Attachment 2 to PLA-6138

Non-Proprietary Version of the PPL Responses

In order to provide technical information that will allow the NRC staff to proceed with its technical review, the following is provided:

Figure 5 - Main Steamline Pressure as a Function of Power

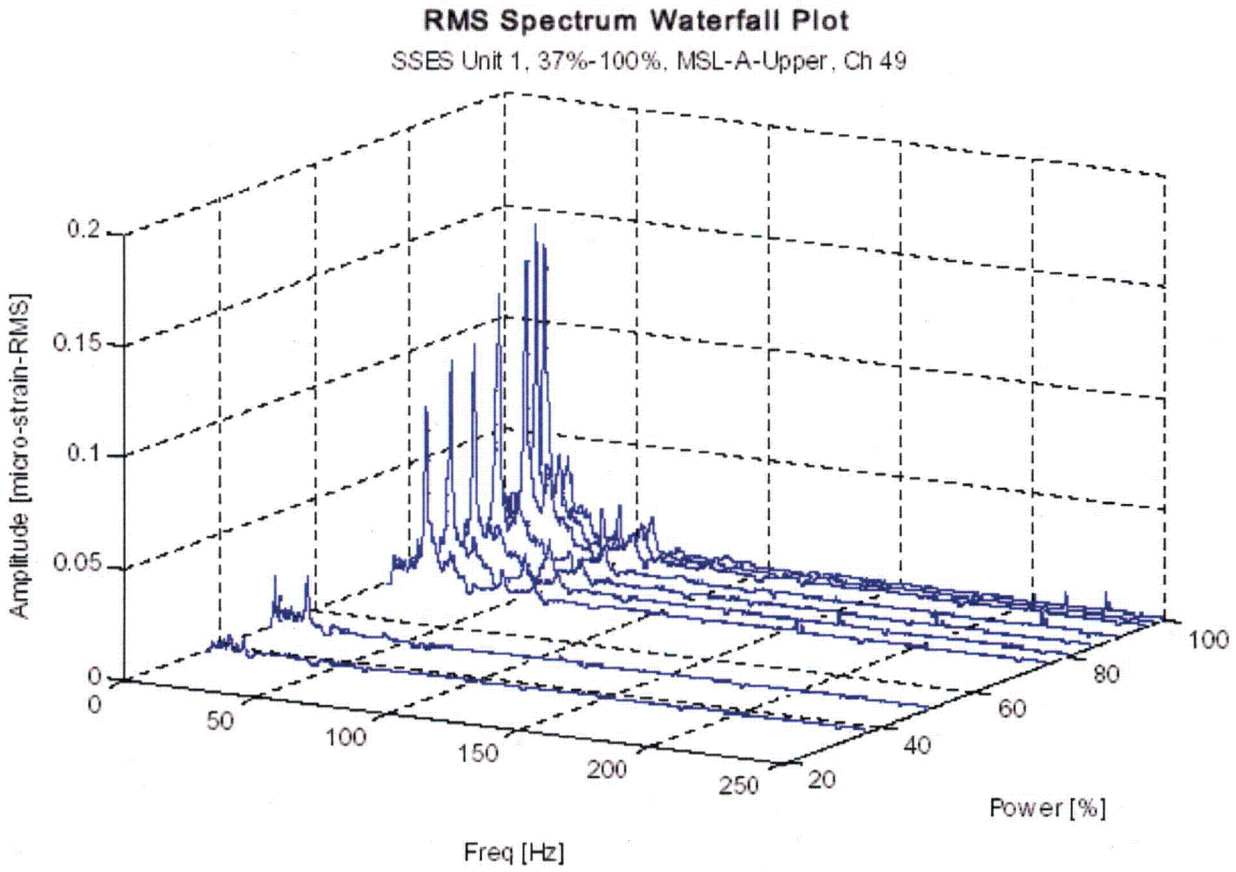
The licensee's submittal indicates the presence of a strong spectral peak at about 110 Hz in the SSES 1 and 2 plant measurements on the steam dryer. The licensee should discuss the source of this peak and the absence of its prediction in the analysis.

The frequency of the observed panel resonance matches the recirculation pump vane passing frequency corresponding to the core flows and recirculation pump speeds present when the measurements were made. The 110 Hz peak observed in the second bank hood panel strain gauge measurements is due to a local structural resonance in the panel where strain gauges S4 and S5 were located. The dryer panels are responding to a strong vibration response in the recirculation loop piping that is excited by the recirculation pump vane passing frequency. The piping vibration is transmitted through the vessel to the dryer supports. This recirculation piping vibration response was first observed in SSES Unit 2 when the plant entered the Increased Core Flow (ICF) region for the first time following licensing of the ICF region.

The recirculation pump vane passing frequency matched a structural mode of the panel at the core flow conditions when the measurements were taken (110 Hz at 100% OLTP and 113 Hz at 90% OLTP). The 110 Hz response was noted at that time of the measurements, as determined in MDE-199-0985-P, Revision 1, which is provided as Appendix 1 of this letter. At that time, the source of the resonance was not investigated. Structural analyses in MDE-199-0985-P, Revision1 determined that the 110 Hz frequency was a structural mode of the second panel. These conclusions were confirmed by performing a vibration analysis using the current whole dryer finite element model. The fatigue evaluation presented in Attachment 10 considered flow-induced vibration resulting from pressure loads applied directly to the dryer. Because the 110 Hz vibration load was transmitted mechanically through the dryer supports, it was not predicted in the pressure load Flow Induced Vibration (FIV) analysis presented in Attachment 10 of PPL's CPPU submittal.

Figures 2 and 3 show the frequency spectra for the second bank strain gauges for power levels from 70% to 100% OLTP. In Attachment 10, a scaling factor was developed in order to adjust the predicted stress results from the finite element analysis to be equivalent to the stresses indicated by the in-plant dryer instrumentation. The scaling factor was based on a comparison of the predicted strains to the measured strains for S4 and S5 at the 100% OLTP power case where the 110 Hz peak is the highest. As discussed above, the 110 Hz peak shown in Figures 2 and 3 were correlated to the recirculation pump vane passing frequency. Because this dominant peak is based on the
